Product Change Notification

Overview: Please be advised that the following is notice of change to Fire Research pressure sensors.

Products Affected: All pressure sensors used for intake and discharge pressure displays, portable testers, pressure governors, and tank indicators.

Fire Research Corp.
 Drawing Number
 XE-XXPT1DWG.R0B
 Date 13JAN06

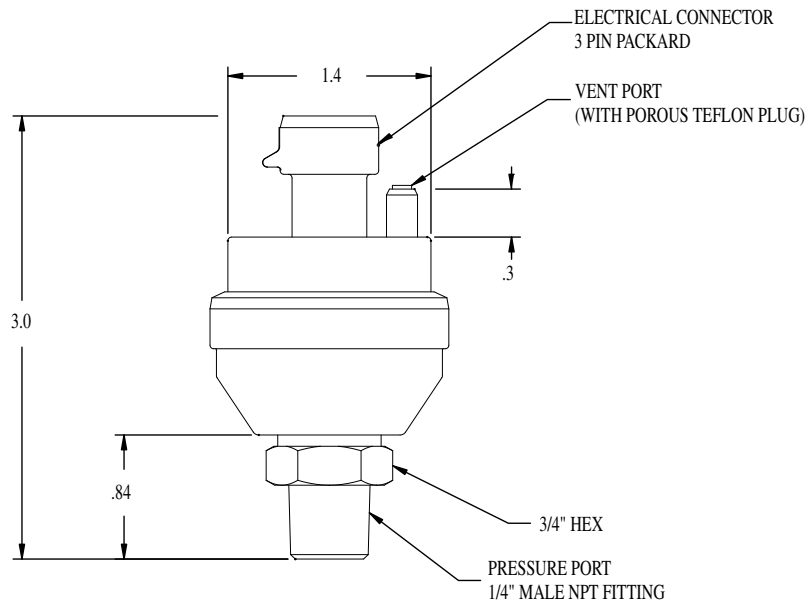
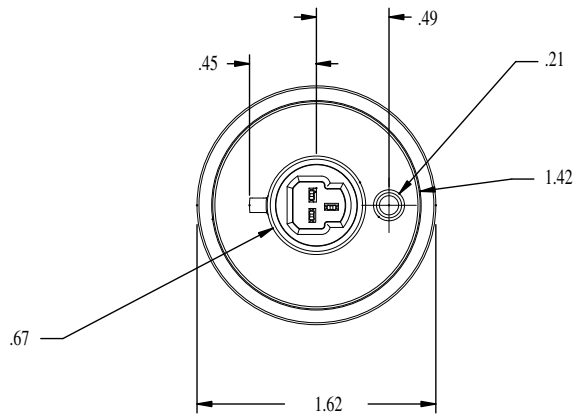
Important Note: The new sensors all have the same dimensions and are slightly larger than the old ones. The difference may be as much as 0.4 inch depending on which old sensor it is compared to. Refer to the referenced drawing for complete dimensions of the new sensors.

Replacement Product: New pressure sensors will be direct replacements. They meet or exceed all electrical and mechanical requirements, use the same 3-Pin Packard connector and mount in a 1/4 inch NPT port.
